AMENDMENT OF SOLICITATION/MODIFICATION OF CONTRACT				1. CONTRACT ID CODE	PAGE OF PAGES	
				J	1	7
2. AMENDMENT/MODIFICATION NO. 0002		3. EFFECTIVE DATE 22-Aug-2006	4. REQUISITION/PURCHASE REQ. NO.		5. PROJECT NO.(If applicable)

14. DESCRIPTION OF AMENDMENT/MODIFICATION (Organized by UCF section headings, including solicitation/contract subject matter where feasible.) The above numbered solicitation for Passes of the Mississippi River, South Pass Maintenance Dredging C/L Station 240+00 to C/L Station 740+00, Plaquemines Parish, Louisiana is hereby amended as follows: BID OPENING DATE & TIME OF 30 AUGUST 2006, 11 a.m., IS ESTABLISHED, LOCAL TIME AT PLACE OF BID OPENING. SECTION 00700, "FAR 52.211-10, COMMENCEMENT, PROSECTUTION, AND COMPLETION OF WORK CLAUSE," PARAGRAPH 1(c), DELETE THE CONTRACT DURATION "212 CALENDAR DAYS" AND SUBSTITUTE "300 CALENDAR DAYS." SEE CONTINUATION PAGES						
Except as provided herein, all terms and conditions of the document referenced in Item 9A or 10A, as heretofore changed, remains unchanged and in full force and effect.						
15A. NAME AND TITLE OF SIGNER (Type or print)			16A. NAME AND TITLE OF CONTRACTING OFFICER (Type or print)

SECTION 01331

SHEET IDENTIFICATION NUMBER
C-04

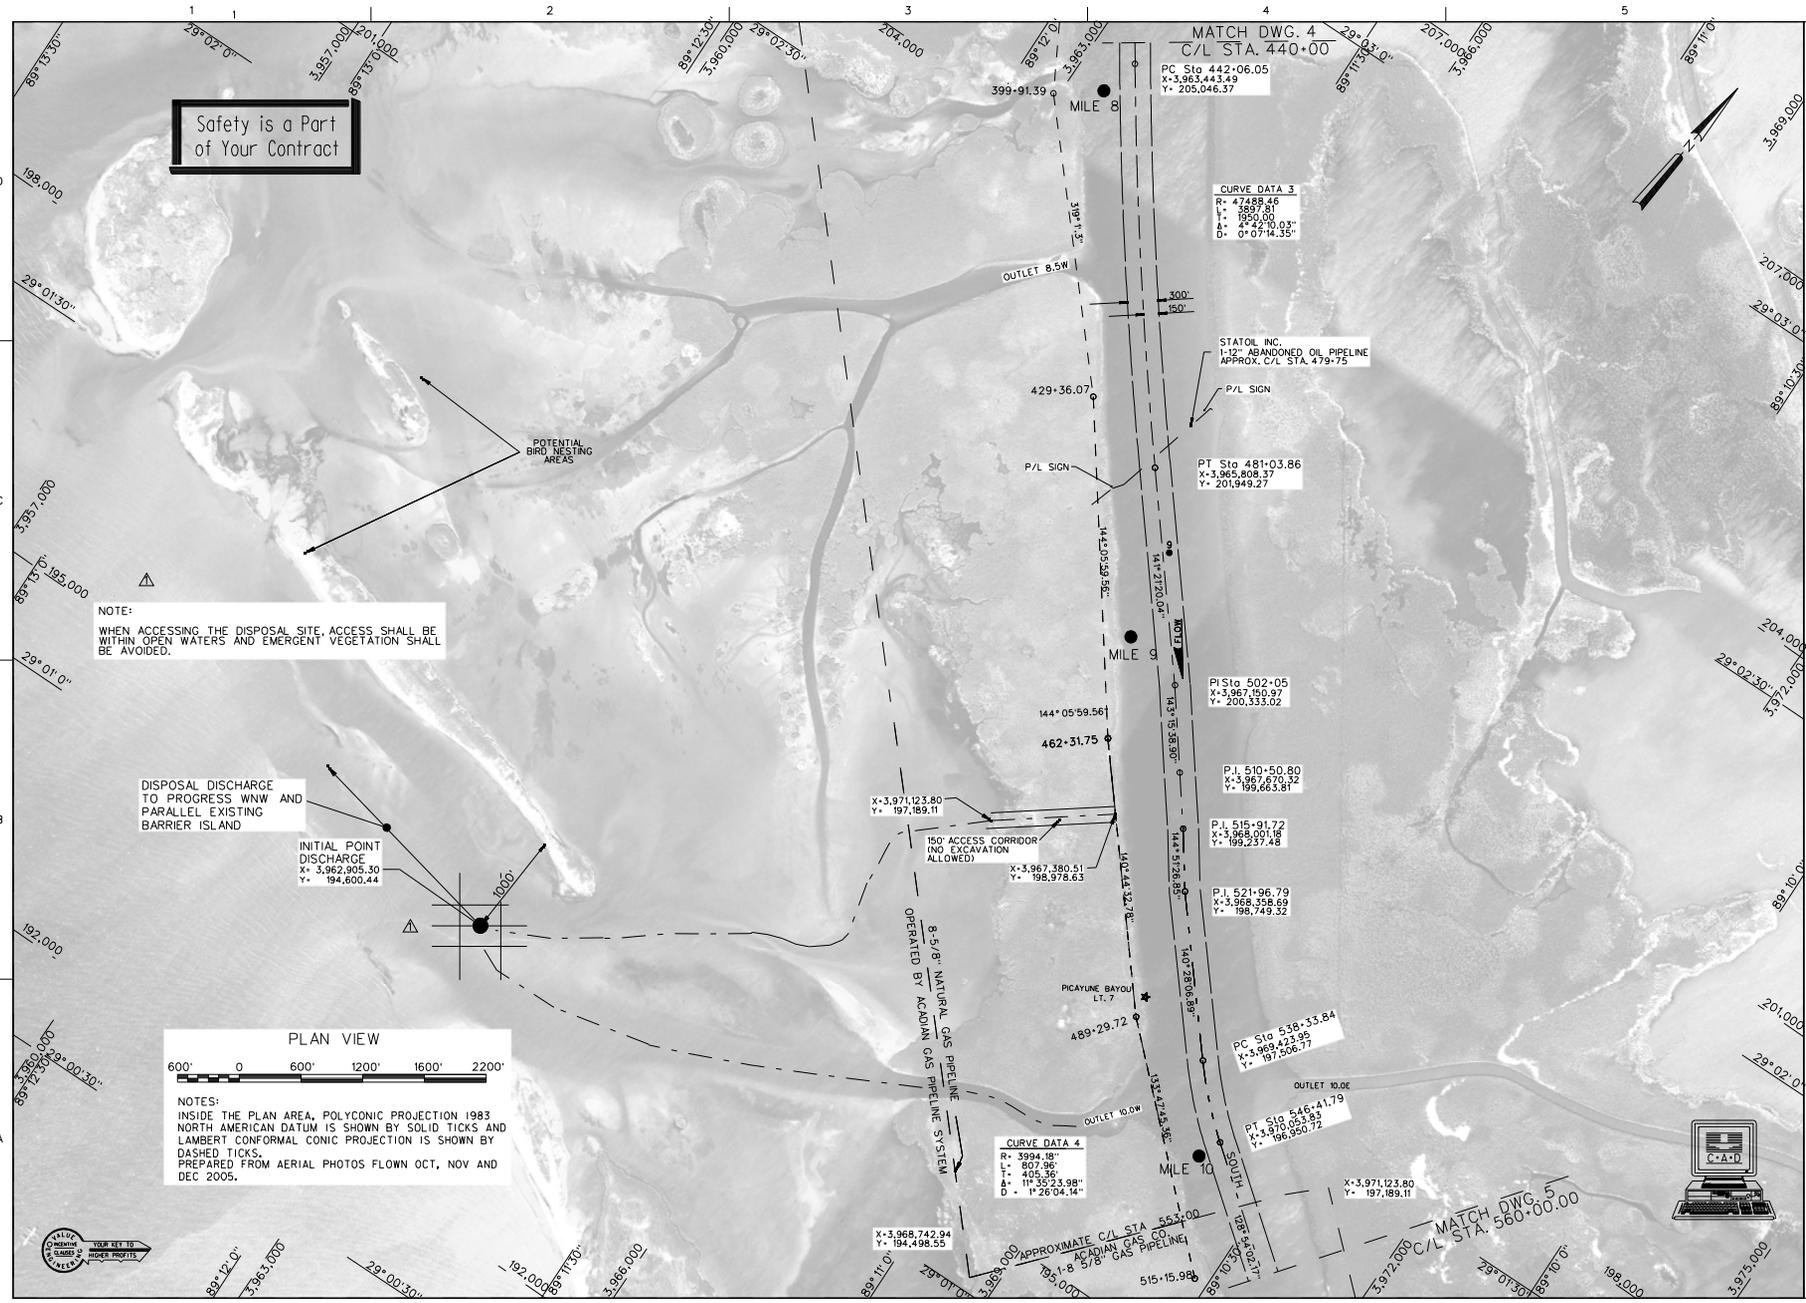
Deleted drawings C-03 thru C-06; file number H-16-45592 in their entirety and substitute with the revised attached drawings C-03 thru C-06.

DISPOSAL DISCHARGE TO PROGRESS WNW AND PARALLEL EXISTING BARRIER ISLAND

INITIAL POINT DISCHARGE
X= 3,962,905.30
Y= 194,600.44
